**Sampling and Analysis Plan
for
Groundwater Monitoring
at the
903 Pad/Ryan's Pit VOC Plume**

**July 1999
Revision 0**

**RESPONSE TO CDPHE and EPA COMMENTS ON THE DRAFT 903 PAD/Ryan's PIT
PLUME SAP**

Figure 4-1

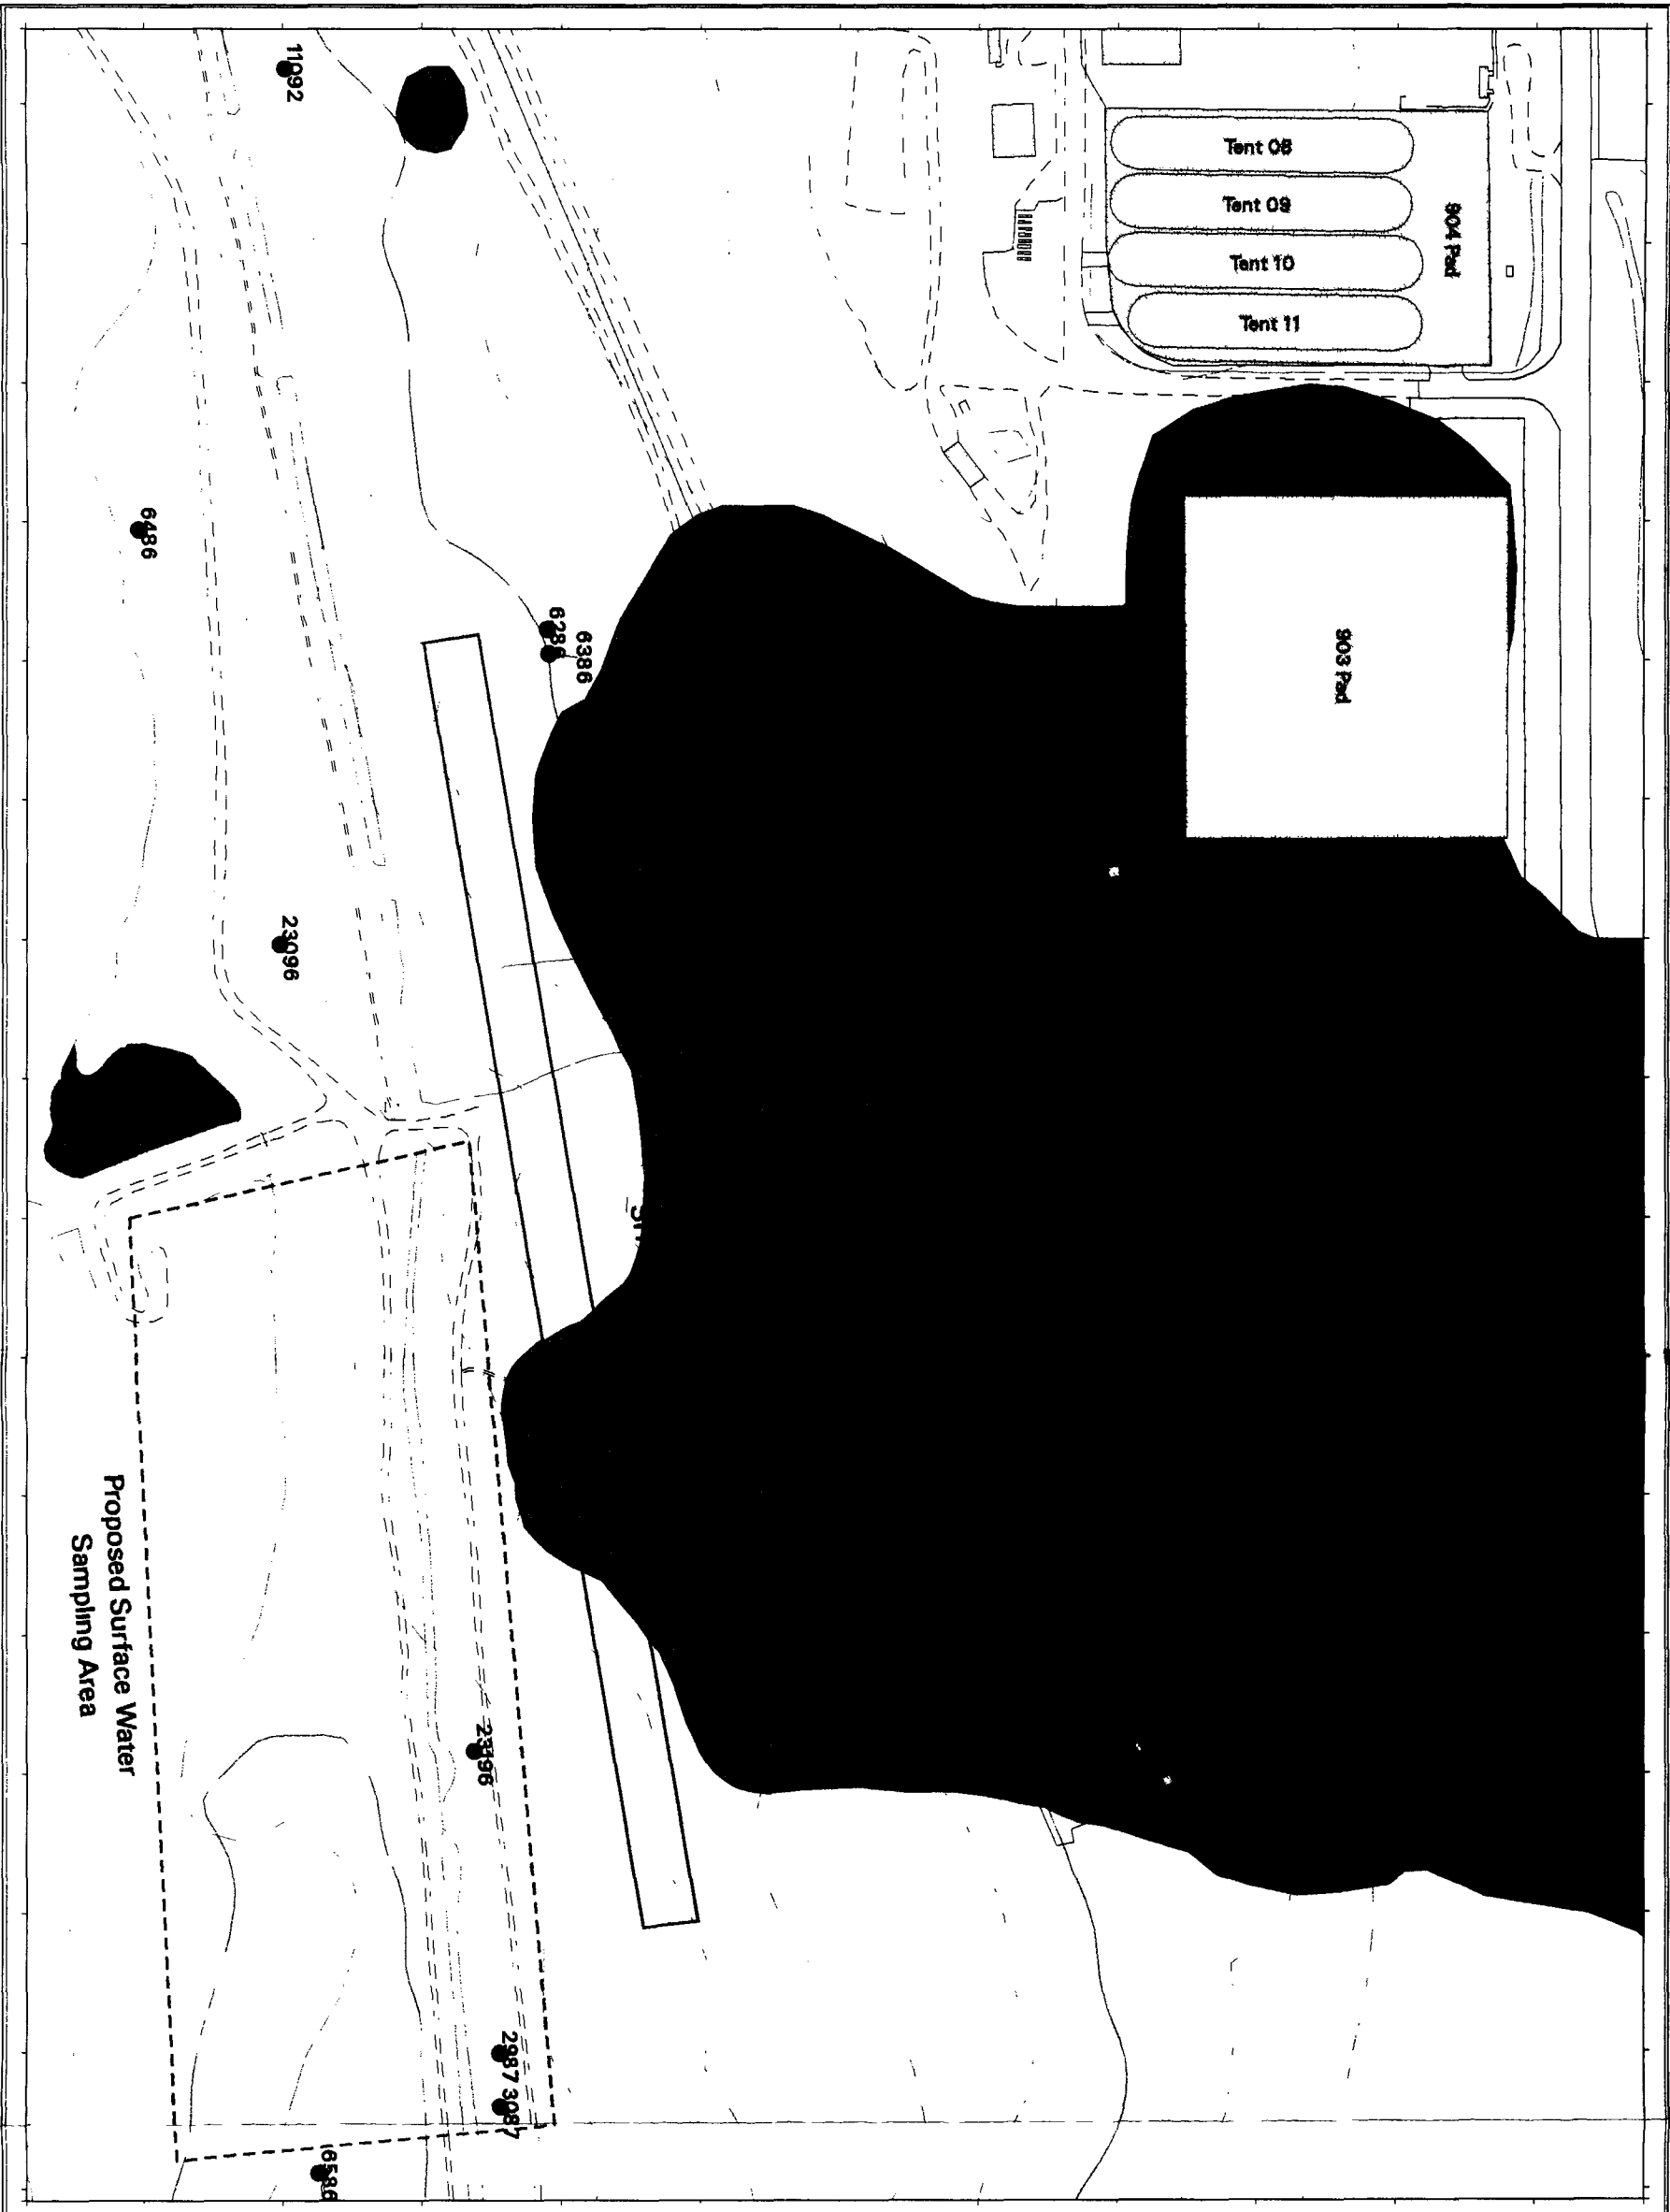
3 Figure 4-1 contains two proposed locations for a well numbered 90199. There is a discrepancy between well 90099 as stated on page 28 and well 90199 on Fig. 4-1.

Response As listed on page 30 and shown on Figure 4-1, Well 90199 will be located due south of well 90099 in the westernmost of the two assumed plume pathways shown. No additional locations for well 90199 could be found on the figure.
